<b>Panel Reference</b>	<b>PPSSNH-393</b>
<b>DA Number</b>	<b>DA-2022/394</b>
<b>LGA</b>	<b>Willoughby City Council</b>
<b>Proposed Development</b>	<b>Demolition of existing site structures and the construction of a multilevel centre-based childcare facility, to accommodate 145 children between the age 0 and 6 years, including a basement comprising of 28 car parking spaces.</b>
<b>Street Address</b>	<b>2 Tessa Street, Chatswood</b>
<b>Applicant/Owner</b>	<b>The Trustee for the Wu &amp; Kuo Family Trust</b>
<b>Date of DA lodgement</b>	<b>22 December 2022</b>
<b>Number of Submissions</b>	<b>83 submission (including one petition)</b>
<b>Recommendation</b>	<b>Refusal</b>
<b>Regional Development Criteria - Schedule 6 to the State Environmental Planning Policy (Planning Systems) 2021</b>	<b>Development over \$5 million for a child care centre pursuant to Clause 5 to Schedule 6 of SEPP(Planning Systems) 2021</b>

**SNPP NO:** PPSSNH-393  
**COUNCIL** WILLOUGHBY CITY COUNCIL  
**ADDRESS:** 2 TESSA STREET, CHATSWOOD NSW 2067.  
**DA NO:** DA-2022/394  
**PROPOSAL:** DEMOLITION OF EXISTING SITE STRUCTURES AND THE CONSTRUCTION OF A MULTILEVEL CENTRE-BASED CHILDCARE FACILITY, TO ACCOMMODATE 145

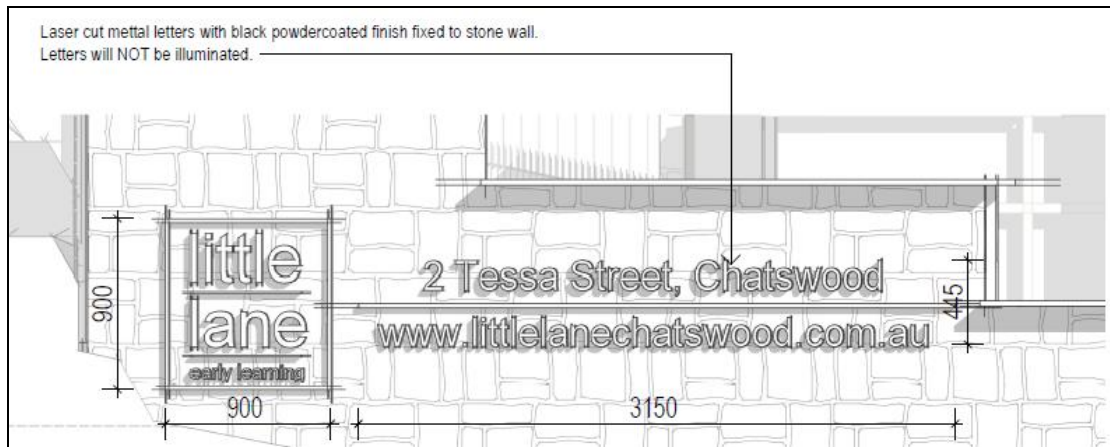
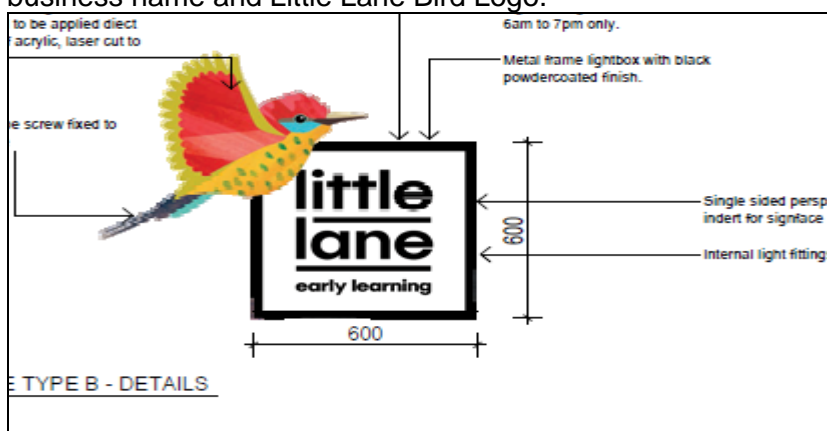
Clause 3.6 requires signage to satisfy the assessment criteria in Schedule 5 (See table below). The following signage have been assessed against the Chapter 3 of the *SEPP (industry and Employment) 2021*.

- Business Identification sign on boundary wall fronting Tessa Street, indicating business name, street address and web address.

- 1 x (600x600mm) business identification sign on Tess Street elevation, indicating the business name and Little Lane Bird Logo.
- 1 x (600x600mm) business identification sign on View Street elevation, indicating the business name and Little Lane Bird Logo.
